TENNESSEE VALLEY AUTHORITY

WATTS BAR NUCLEAR PLANT UNITS 1 AND 2 - RESPONSE TO NRC REGION II INSPECTION
REPORT 50-390/84-71 AND 50-391/84-47

ENCLOSURE

Figure 1. Daytime Wind Roses for the 46m and 10m levels of the Watts Bar Meteorological Facility, based on January 1, 1981 - December 31, 1983 data.

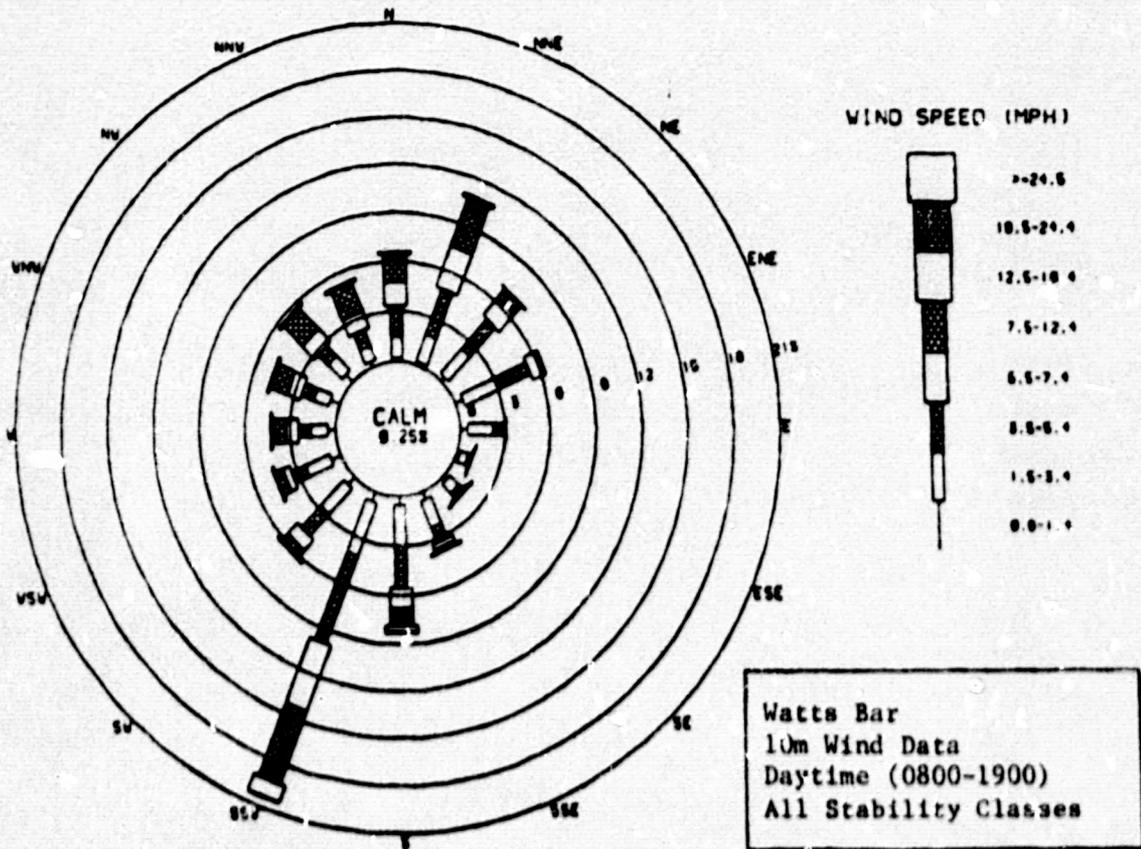
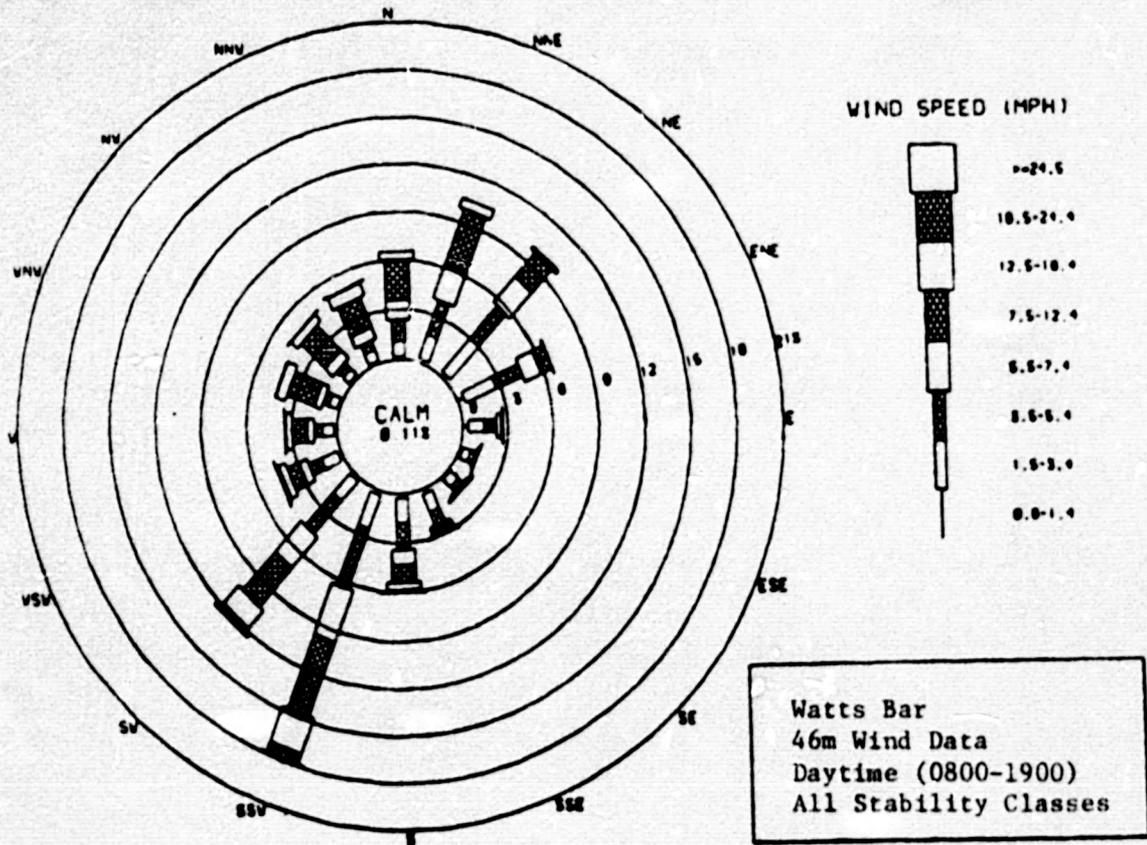
- c. The use of 46m wind speed and direction information in lieu of 10m information should be substantiated.

TVA has elected to use 46m wind data in lieu of 10m wind data in emergency preparedness procedures. Use of the 46m data is expected to result in better estimates of plume transport in the Watts Bar Nuclear Plant area by avoiding local influences which are reflected in the 10m wind data.

In figure 1, daytime wind roses for both levels (based on January 1, 1981-December 31, 1983 onsite data) are noted to be quite similar. The most noticeable difference is a higher

frequency of southwest winds at the 46m level. Mean daytime wind speeds for the 10m and 46m levels were 5.2 and 6.9 mi/h, respectively.

Figure 2. Nighttime Wind Roses for the 46m and 10m levels of the Watts Bar Meteorological Facility, based on January 1, 1981 - December 31, 1983 data.

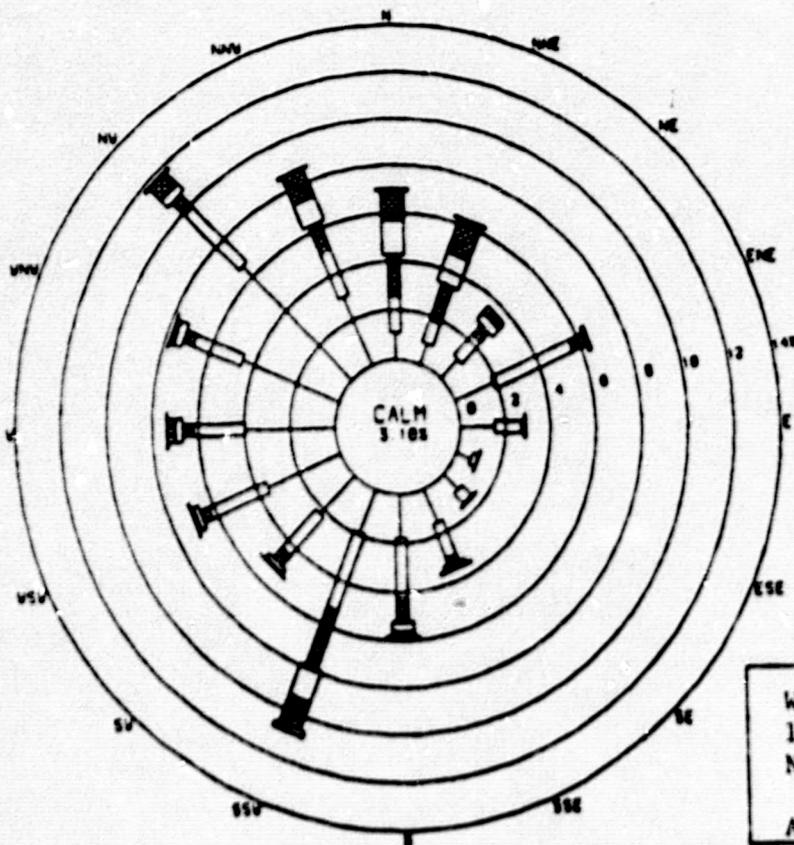
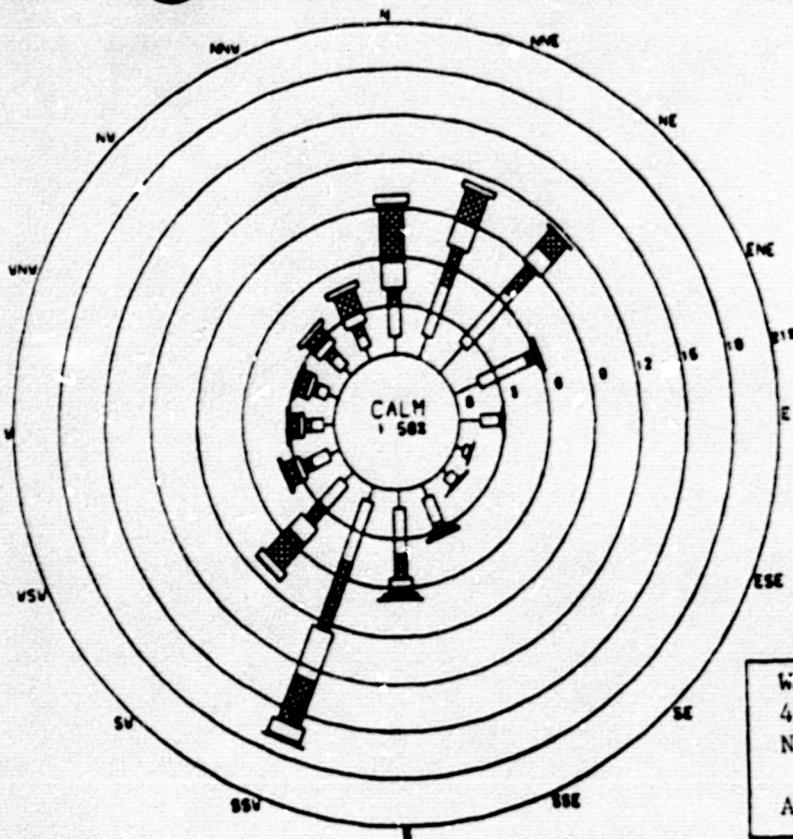
- d. The reference to "local influences" affecting data collection at the 10m level should identify the "local influence."

Figure 2 includes the nighttime wind roses for the two levels (note different scales) for the same data period. A much higher frequency of very light winds from the west-southwest through northwest directions is noted at the 10m level than at the 46m level. These light winds occur most frequently with F or E stability classes, which account for 56 percent of the nighttime stability observations. Airflow from these directions under stable conditions is not expected to persist very far from the plant. Mean nighttime wind speeds for the 10m and 46m levels were 2.9 and 4.8 mi/h, respectively.

The local influence on dispersion of primary concern at Watts Bar is the high frequency of light winds, from the west-southwest through northwest directions, measured at the 10m level but not the 46m level of the meteorological tower under nighttime stable conditions (see figure 2). This influence may result from a flow of cool air downslope from a low northeast-southwest aligned ridge located about 1.5km northwest of the meteorological tower. Under stable conditions, the closest ridge on the opposite side of the river would block these light winds and would tend to divert them, most probably in a downvalley manner. For this reason, the influence is considered to be local.

Figure 3. Plume location based on the following meteorological data:

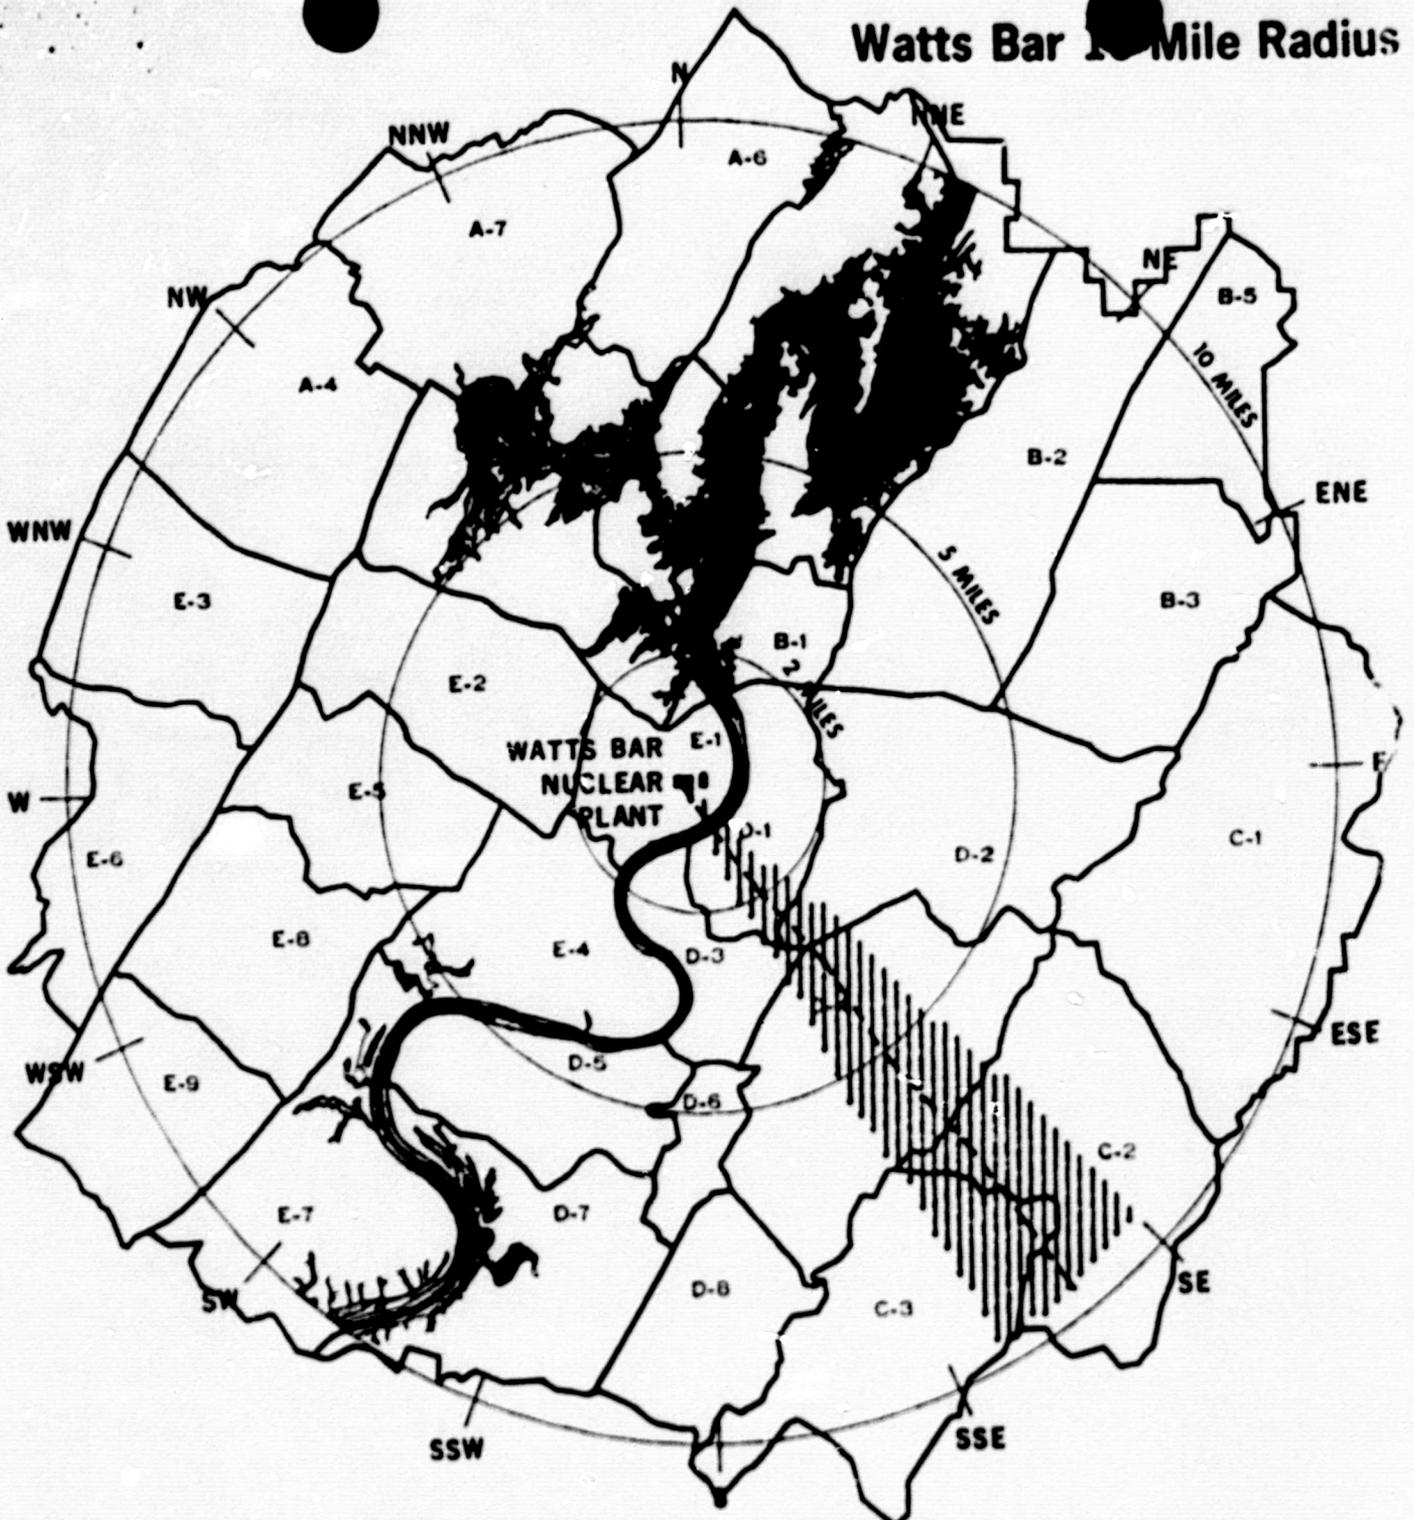
- e. Failure to use 10m data for ground level releases, a deviation from standard procedures, should be justified.

Figures 3 and 4 are plume plots based on onsite data for 2100 on January 21 through 0400 on January 22, 1984. The 10m plot (figure 3) shows the plume apparently moving over the higher terrain to the southeast. This plot shows the effect of the local influence, discussed in question d. above, on the model calculations. The 46m plot in figure 4 gives a more realistic indication of potential plume transport under these conditions.
